# **Remedy Optimization Team Report for the Bethpage Groundwater Plume Remedy**

**- Presented to the Southeast Nassau Water District Committee  
June 23, 2011**

# Navy Bethpage Project Team's Response to Optimization Report

# Plume appears in Aqua NY, but not in outpost well

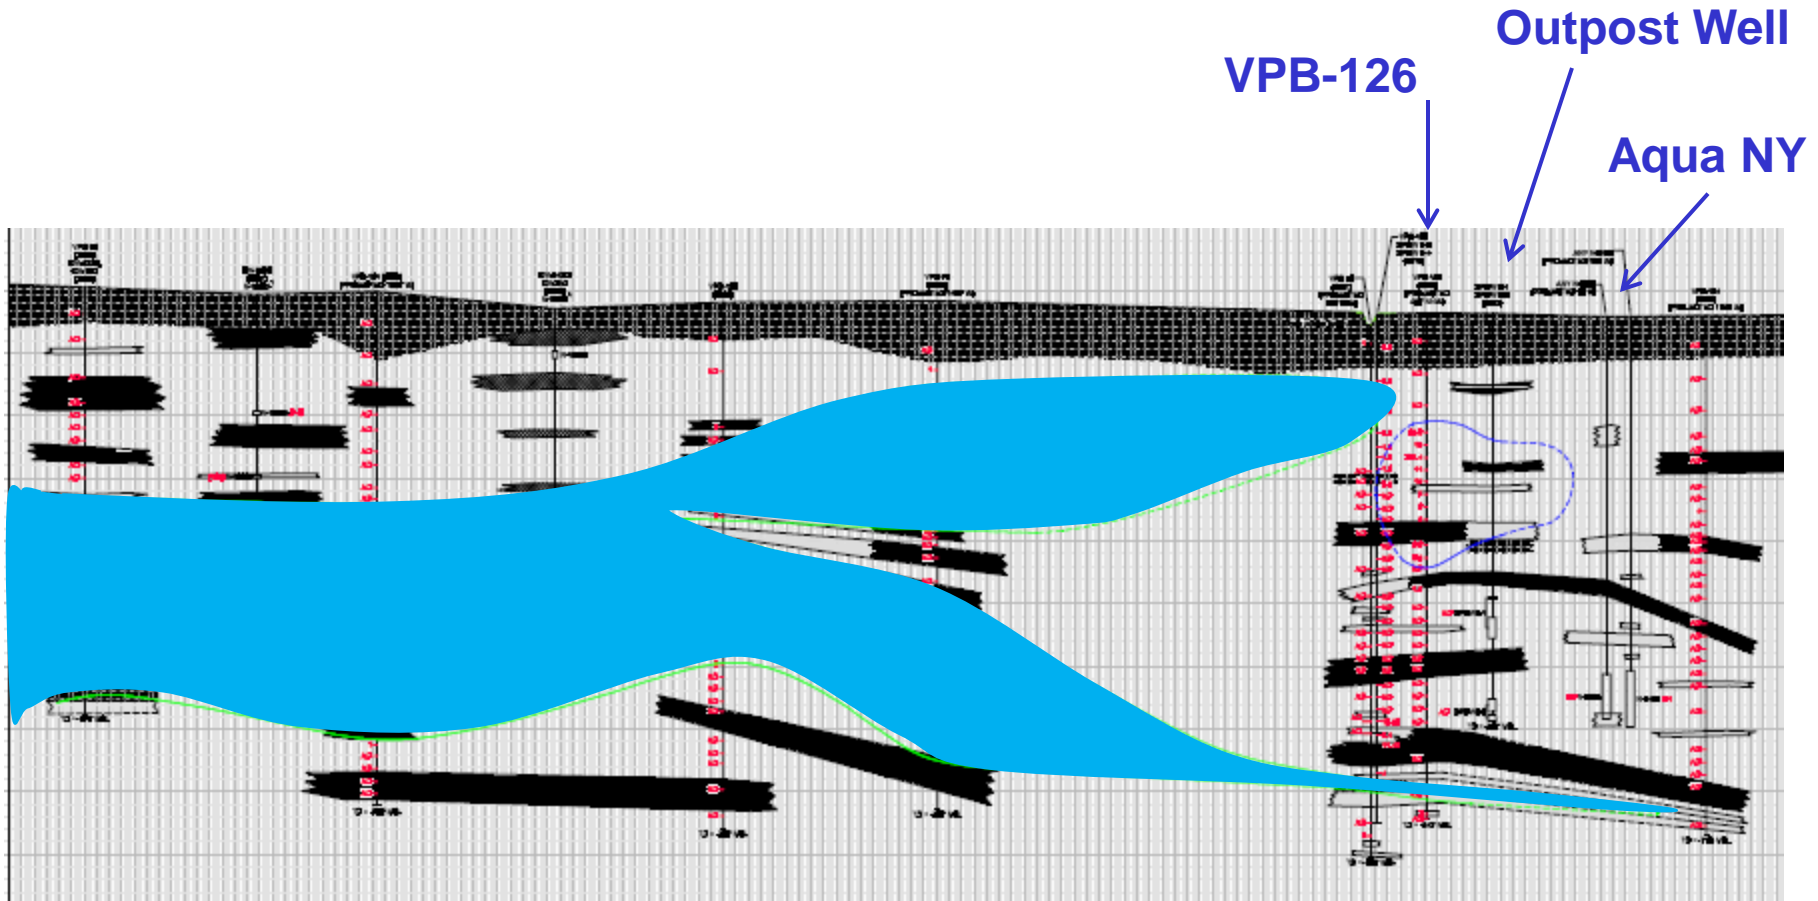
- Vertical Cross-Section AA' through long axis of the OU-2 Plume

# Conclusions/Recommendations

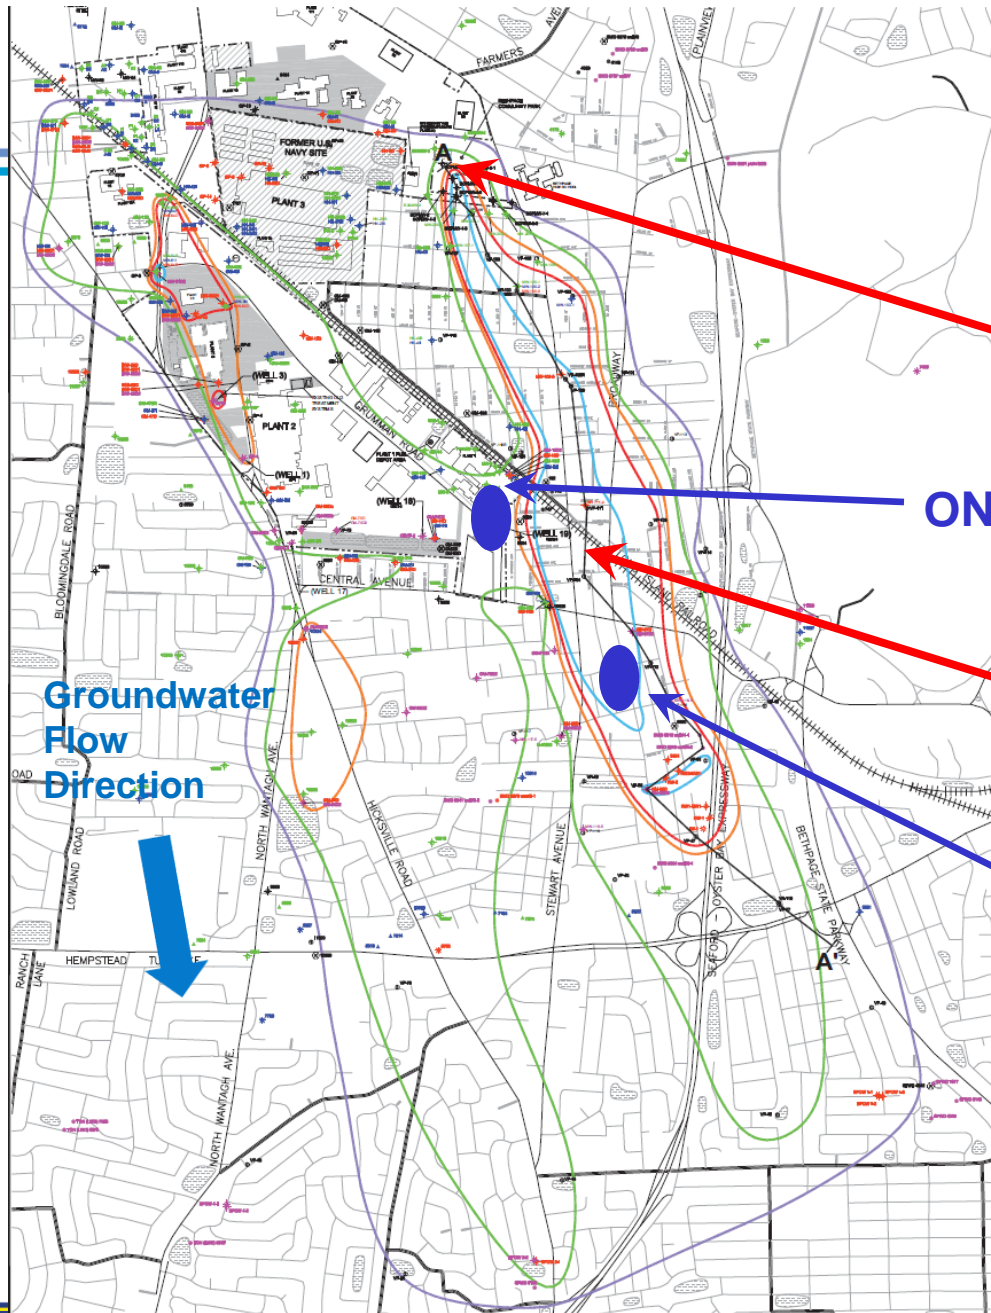
- The OU-3 Plume has an off-site hotspot that represents much higher contamination than in the rest of the off-site plume
  - Recommendation: Use a new extraction well(s) upgradient of Bethpage Water District Plants 4, 5, and 6 to reduce mass discharge across a vertical containment cross-section of the Eastern Plume by at least 90%
  - Recommendation: Avoid reducing the current extraction rate of existing OU-2 well RW-19 to accommodate new extraction wells
